**Amendments to the Drawings**

### **REMARKS/ARGUMENTS**

In response to the Examiner's first Office Action of November 29, 2005 the Applicant respectfully submits the accompanying Terminal Disclaimer with respect to USSN 10/760,191, Amendment to the specification, drawings and claims, and the below Remarks directed thereto.

FIG. 43

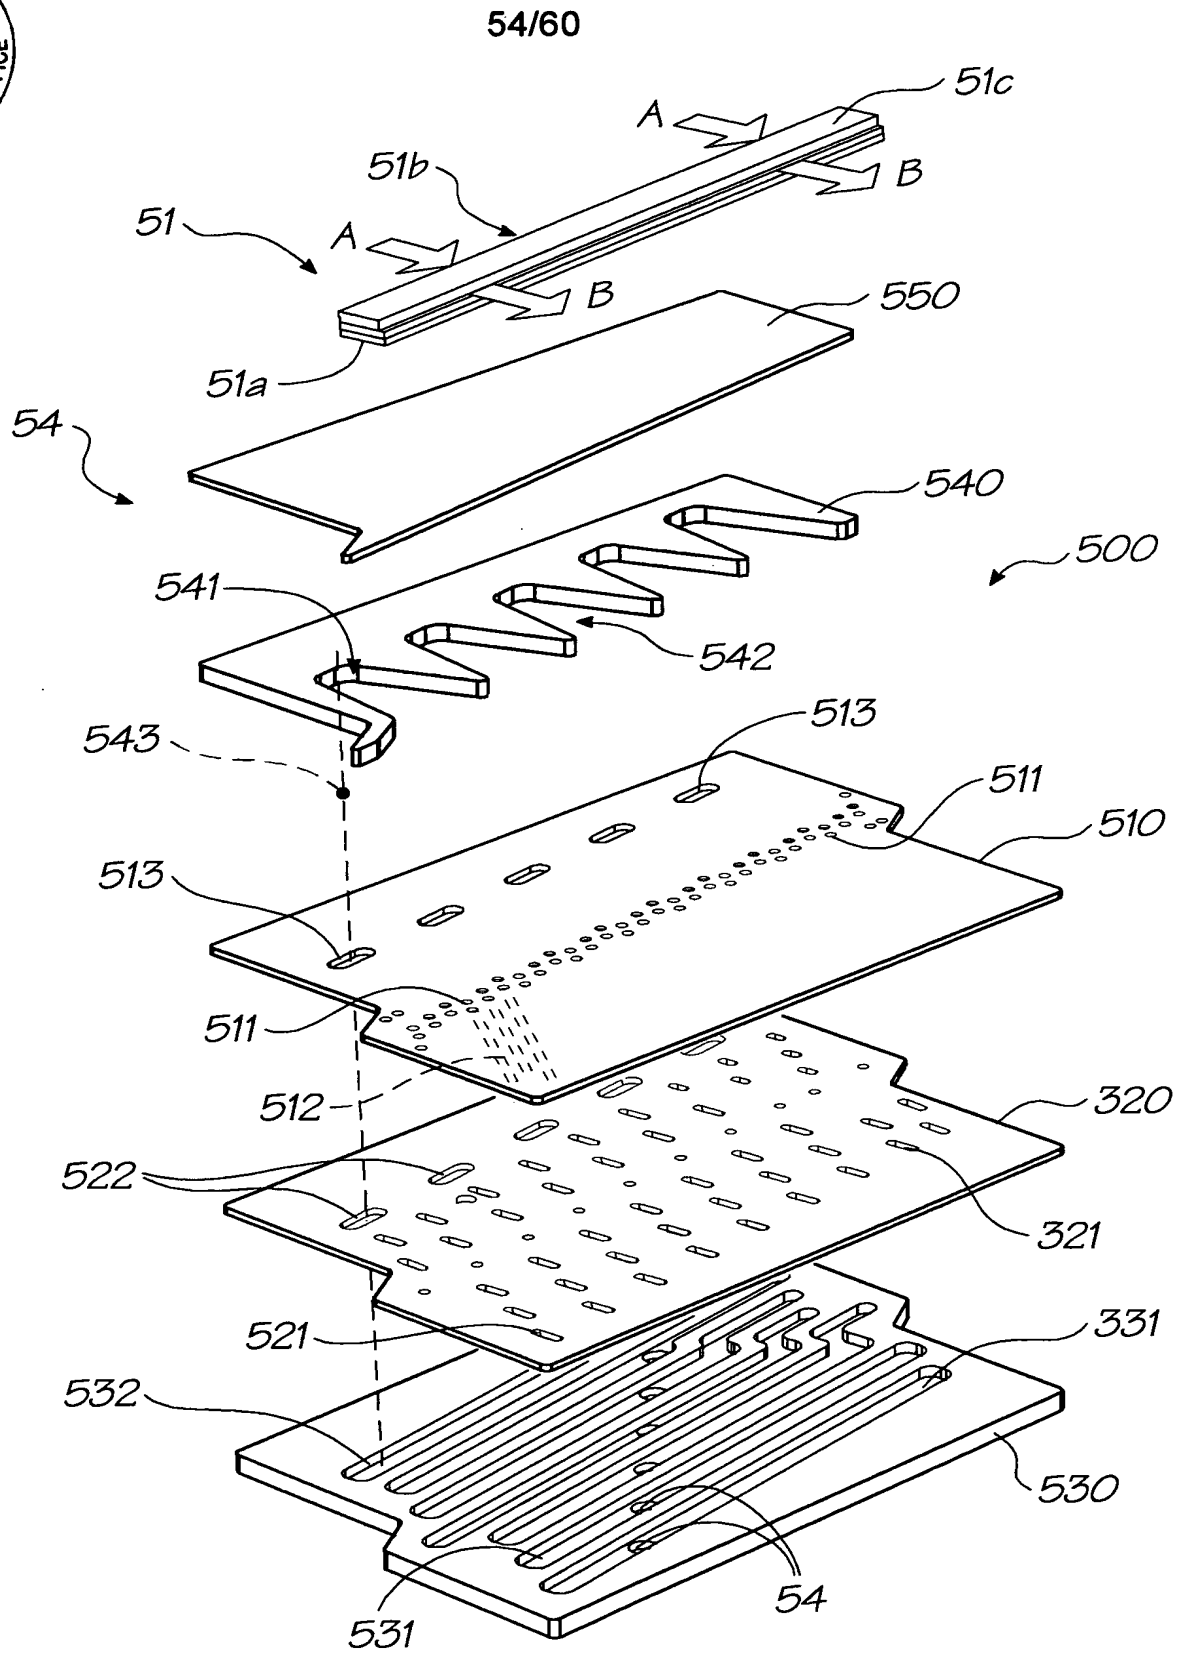
Fig. 43 is amended to include the reference sign "500", as is described at page 8, lines 19-27 of the present specification;

*Regarding reference sign "500"*

A corrected Fig. 43 is enclosed.

It is respectfully submitted that the above-described amendment to Fig. 43 to insert the reference sign "500", provides the correction required by the Examiner.
